Project: Engineering, Procurement and Construction of the New Administrative Capital Monorail and 6th October City Monorail (Contract 93/Metro).

Subject: Comments on shop drawings. // 93M-BOA-NAT-LOT-21635

93M-BOA-NAT-LOT-21635

DRAWING TITLE
6TH OF OCTOBER MONORAIL
SERVICE WALKWAY
ZONE (1016)
3D VIEW

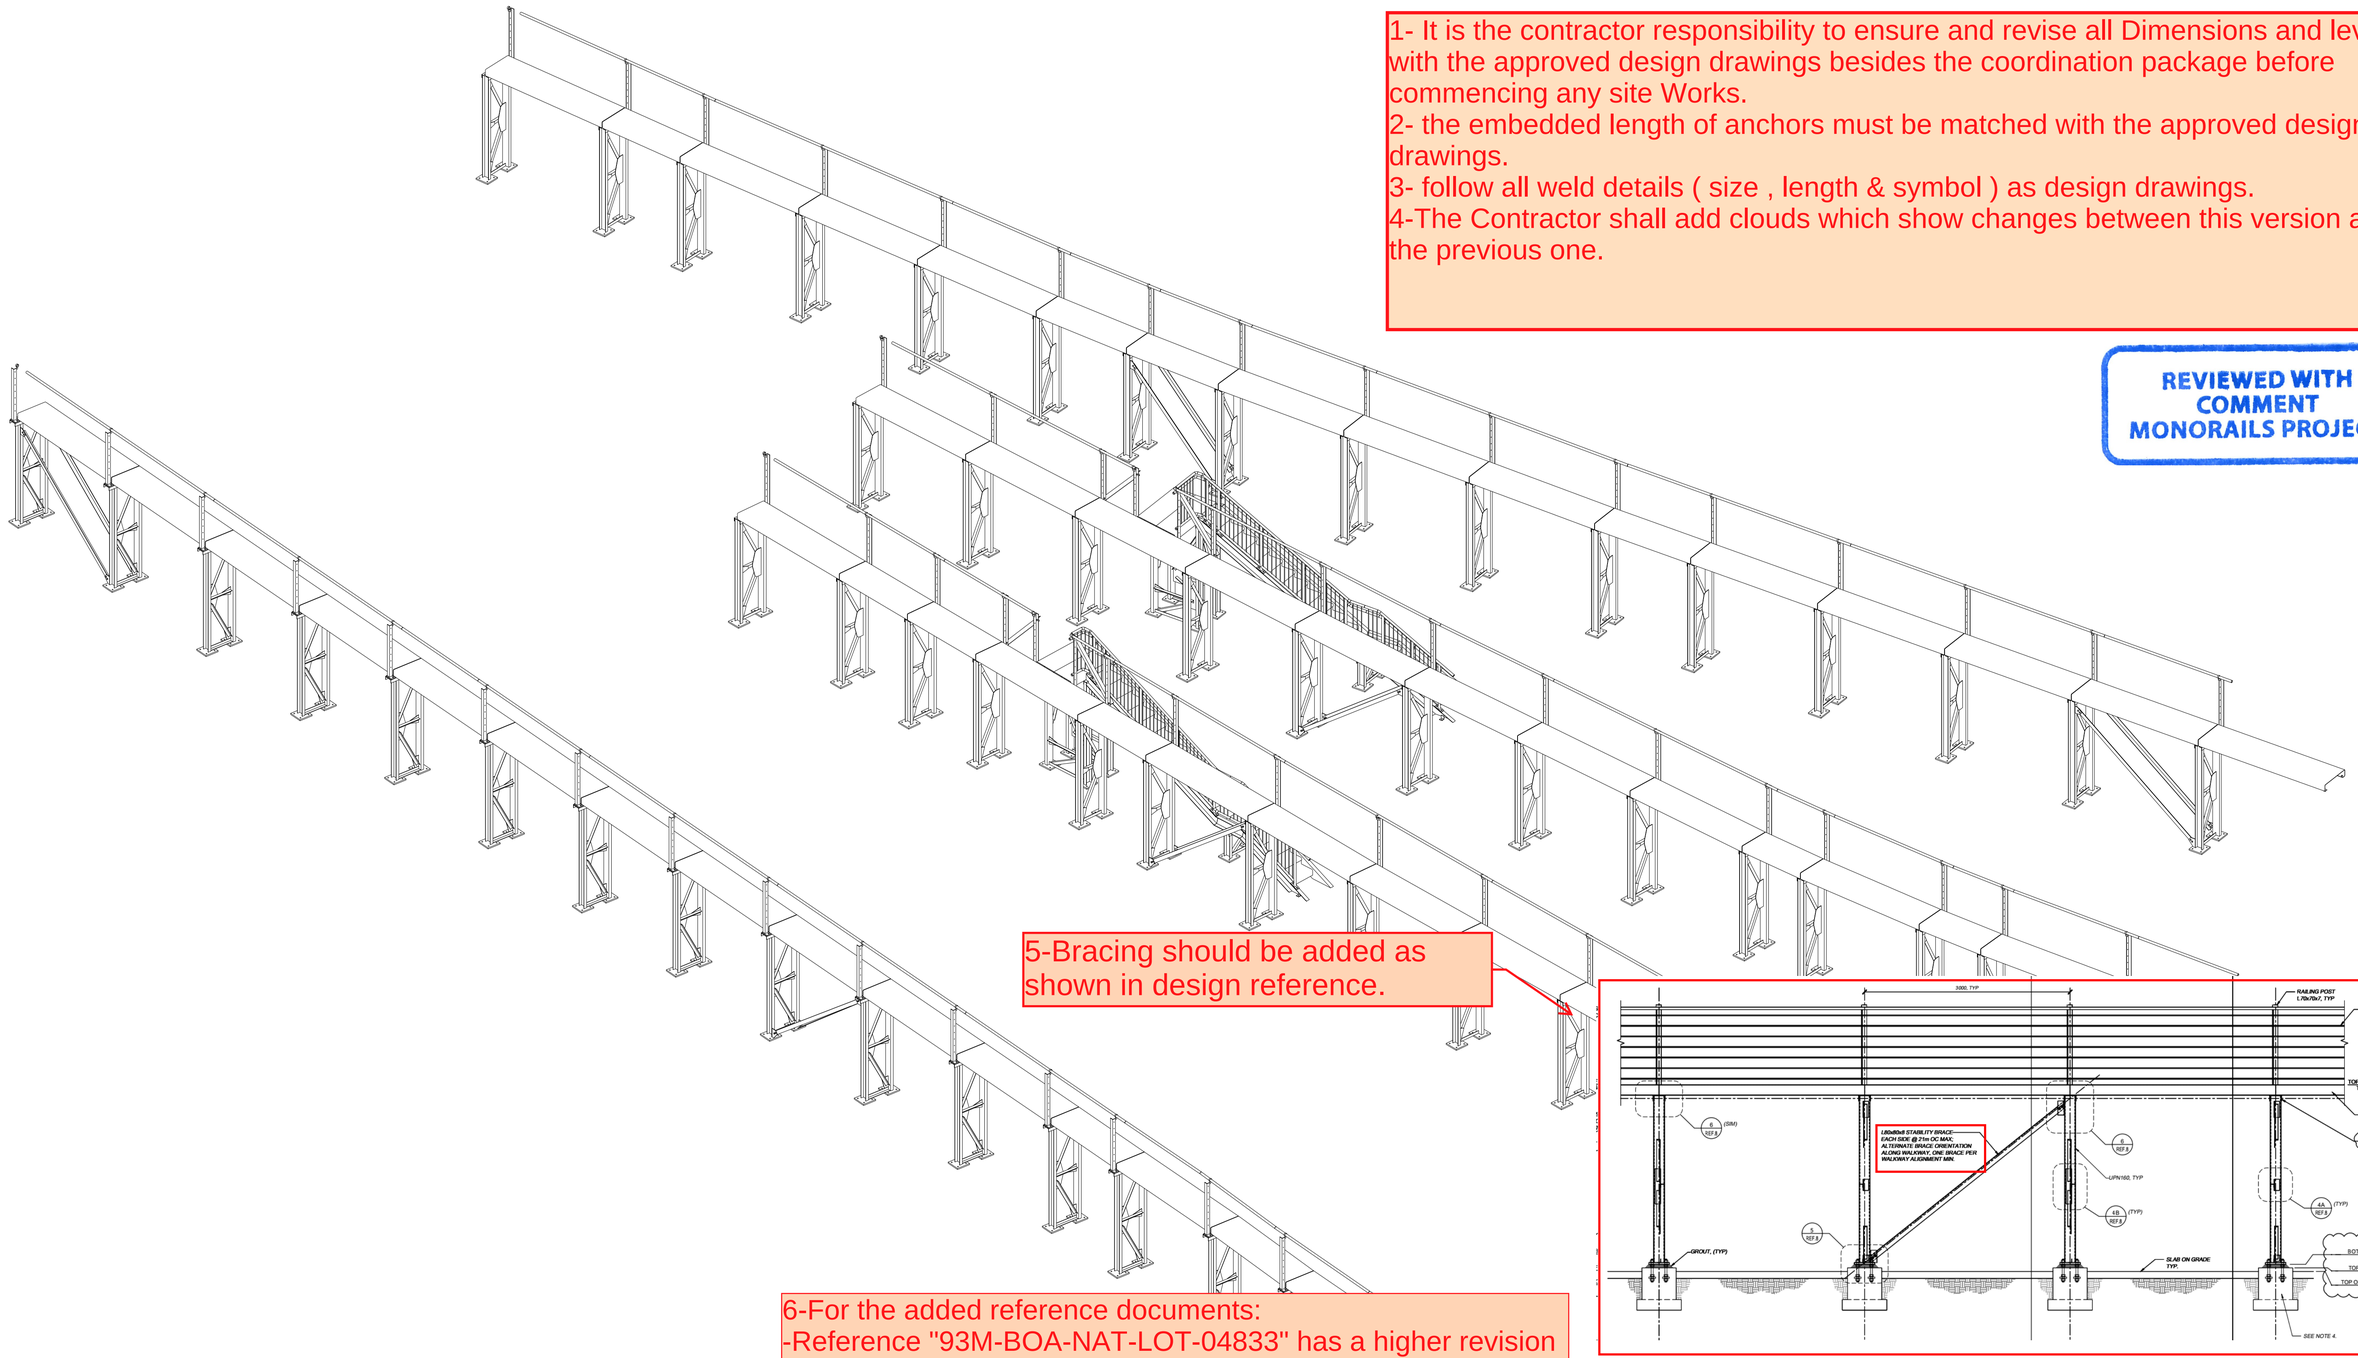
1- It is the contractor responsibility to ensure and revise all Dimensions and levels with the approved design drawings besides the coordination package before commencing any site Works.
2- the embedded length of anchors must be matched with the approved design drawings.
3- follow all weld details (size , length & symbol) as design drawings.
4-The Contractor shall add clouds which show changes between this version and the previous one.

5-Bracing should be added as shown in design reference.

6-For the added reference documents:
-Reference "93M-BOA-NAT-LOT-04833" has a higher revision which is "93M-BOA-NAT-LOT-17034".
-Reference "93M-BOA-NAT-LOT-01976" has some drawings which have a "not approved" status and it's drs replies which is coded as 2 "approved as noted" are found in reference " 93M-BOA-NAT-LOT-07873" which should be added.
so please update the reference documents accordingly.

DRAWING TITLE
6TH OF OCTOBER MONORAIL
SERVICE WALKWAY
ZONE (1016)
BASE PLAN

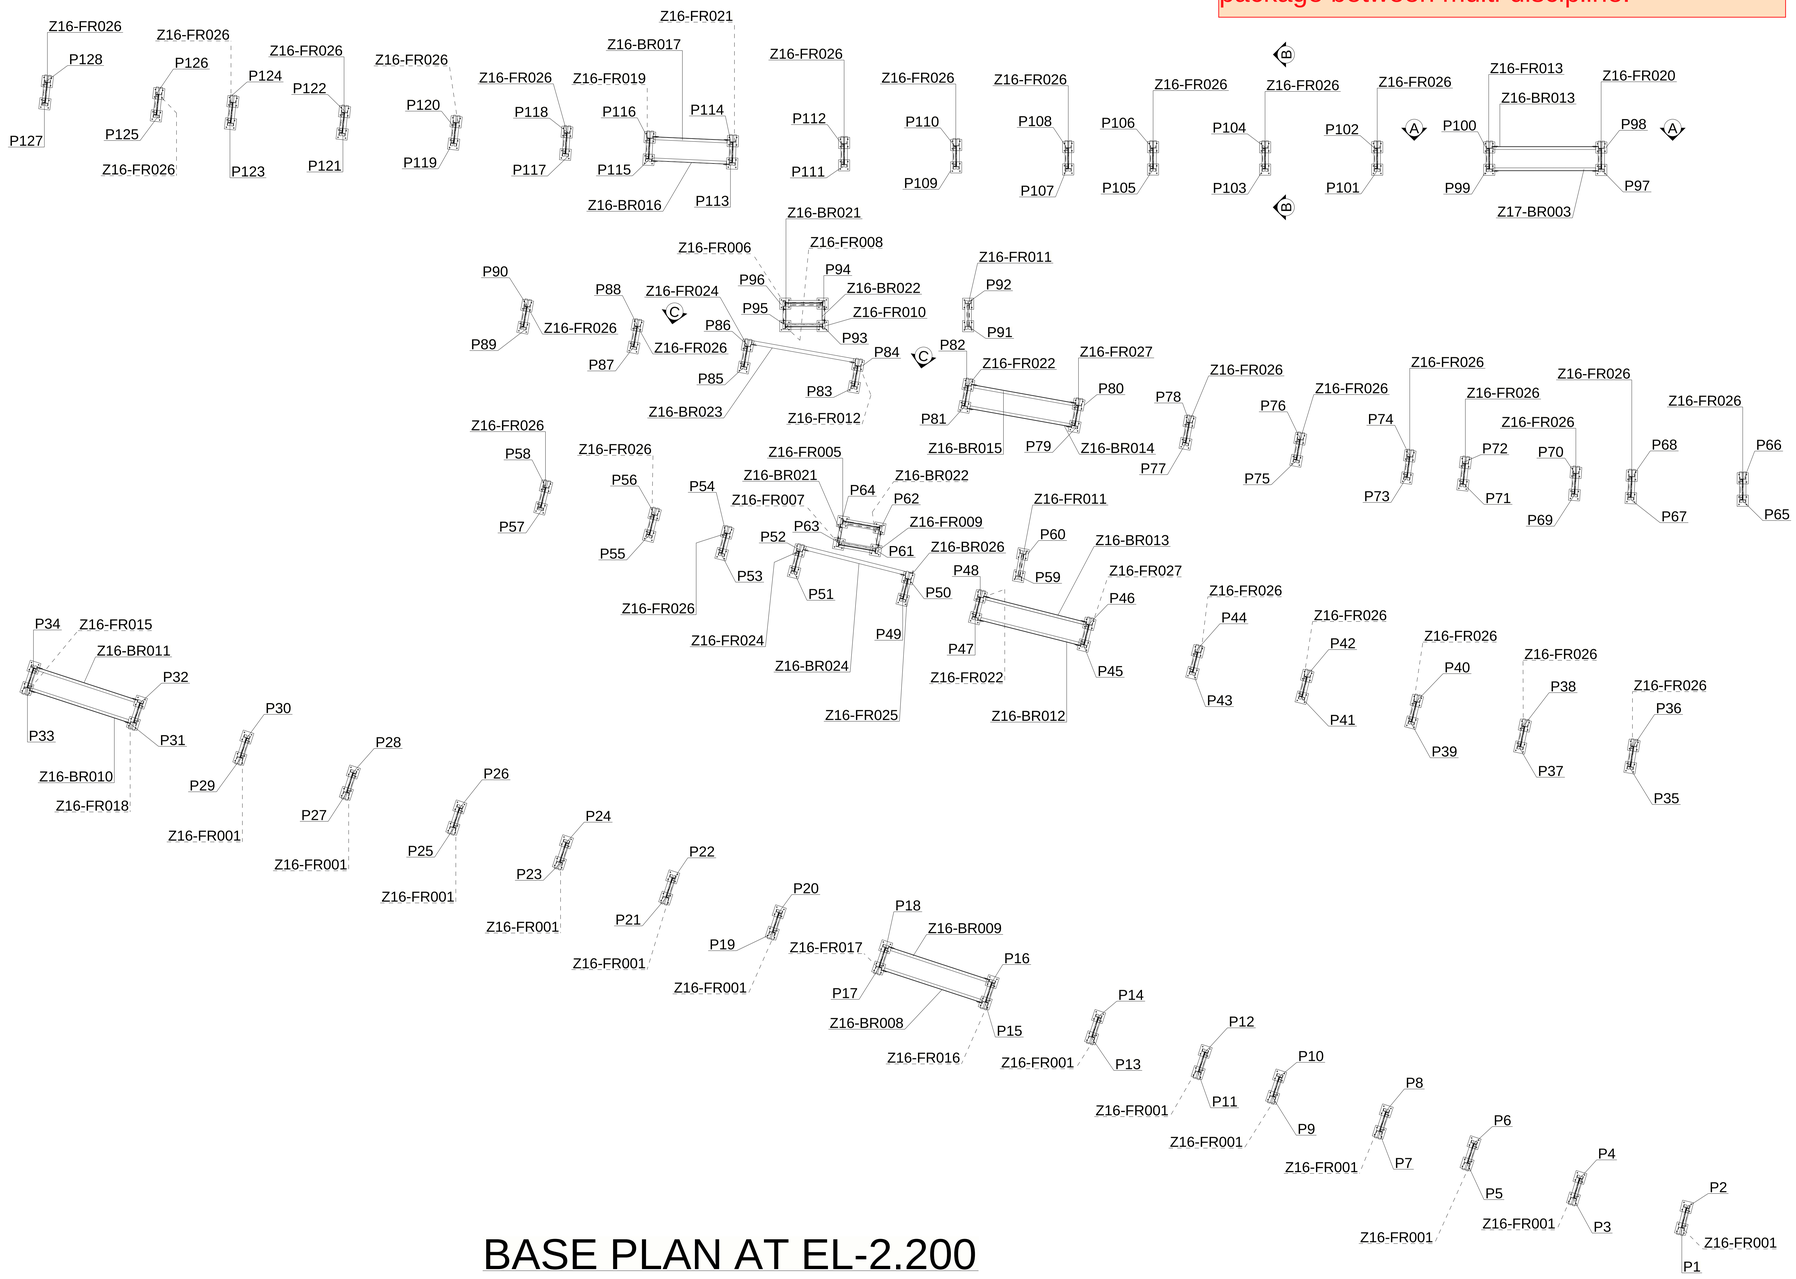
Approval is subject to approval of coordination package between multi-discipline.

DRAWING TITLE
6TH OF OCTOBER MONORAIL
SERVICE WALKWAY
ZONE (1016)
PLAN AT EL+0.350

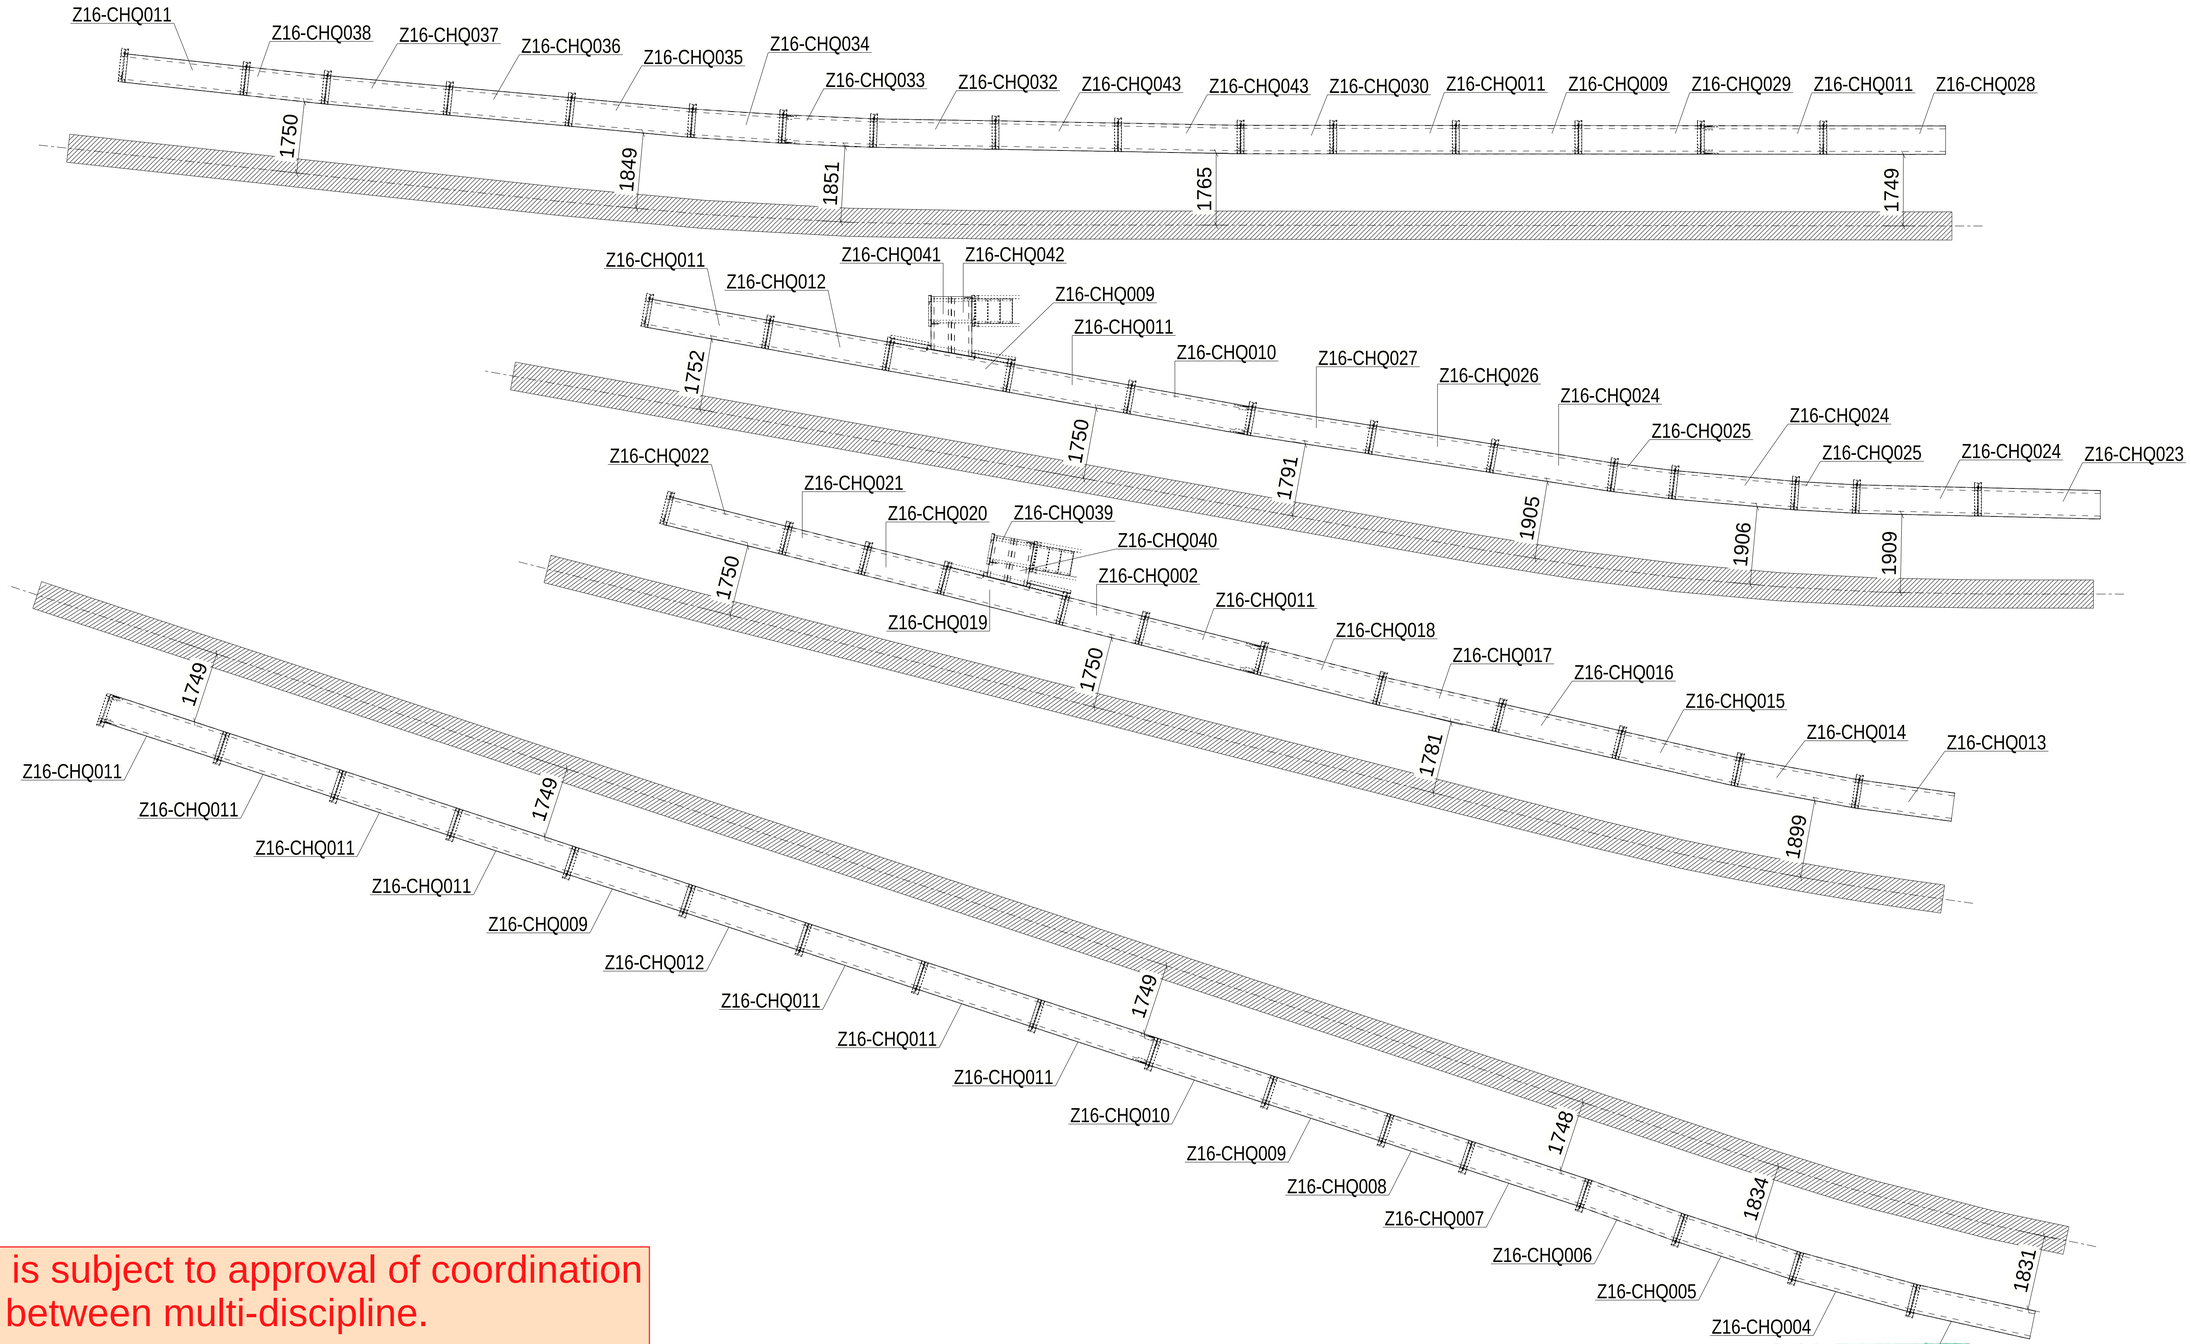
Approval is subject to approval of coordination package between multi-discipline.
